Economic Commission for Europe**Inland Transport Committee****World Forum for Harmonization of Vehicle Regulations****Working Party on Lighting and Light Signalling (GRE)****Sixty-Ninth session**

Geneva, 8-11 April 2013

**Regulations Nos. 3, 4, 6, 7, 19, 23, 38, 65, 69,
70, 77, 87, 91, 98, 112, 113, and 119****Proposal for Supplement 24 to the 01 series of amendments
to Regulation No. 6 (Direction indicators)****Submitted by the expert from Germany***

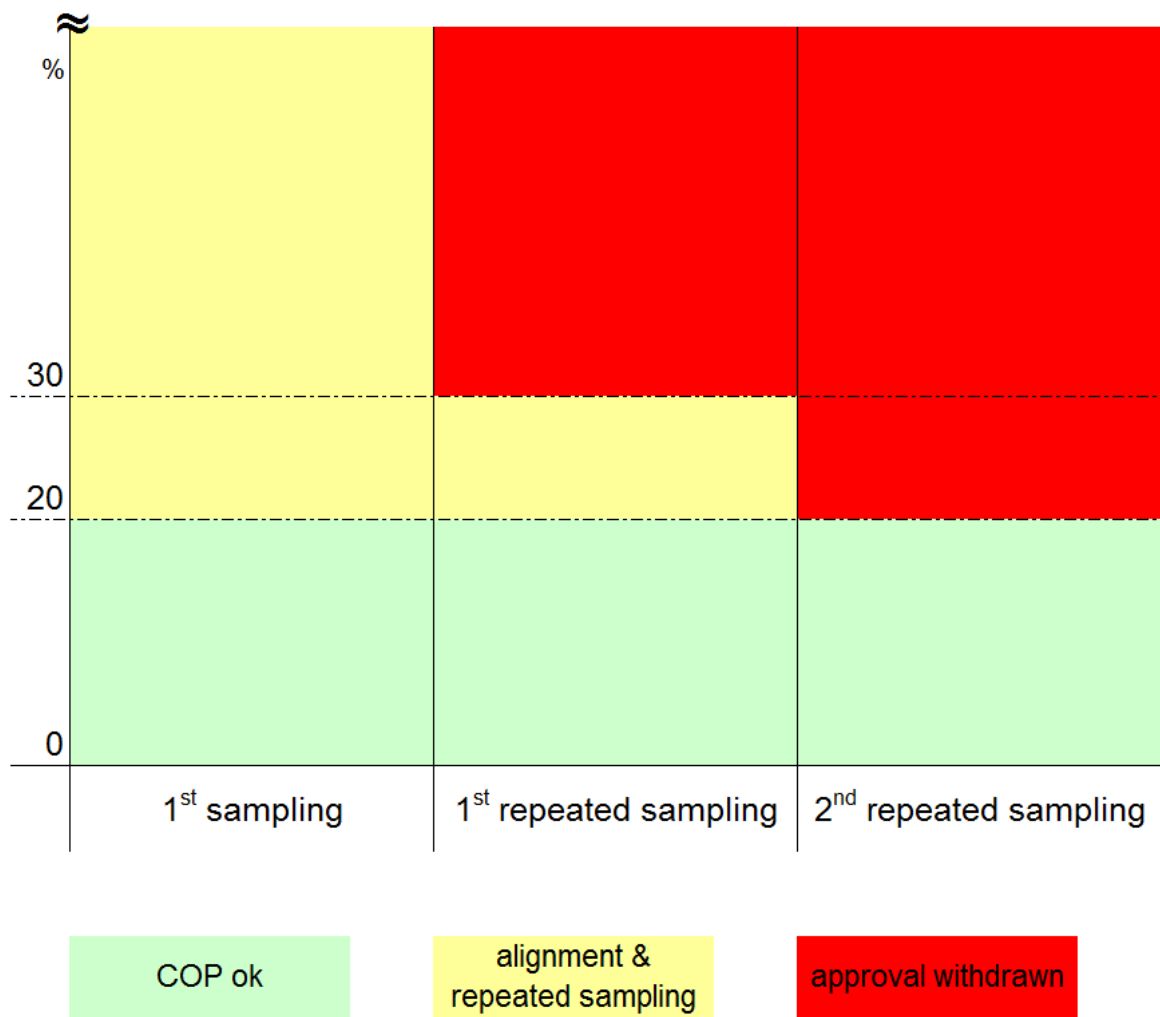
6. CoP is now described in a clear structured stepwise process (with limited steps), which gives the manufacturer the chance in the first step - in the case of deviations of more than 20 per cent - to align his production process. Also, the CoP process can be completed earlier when the first two samples are in the full specifications.

7. The proposal details the "third step" which defines the condition where the approval shall be withdrawn, when after the second repetition of this process the manufacturer was not in the position to "align" his production process in the correct way.

8. The attached drawing shall demonstrate this stepwise process.
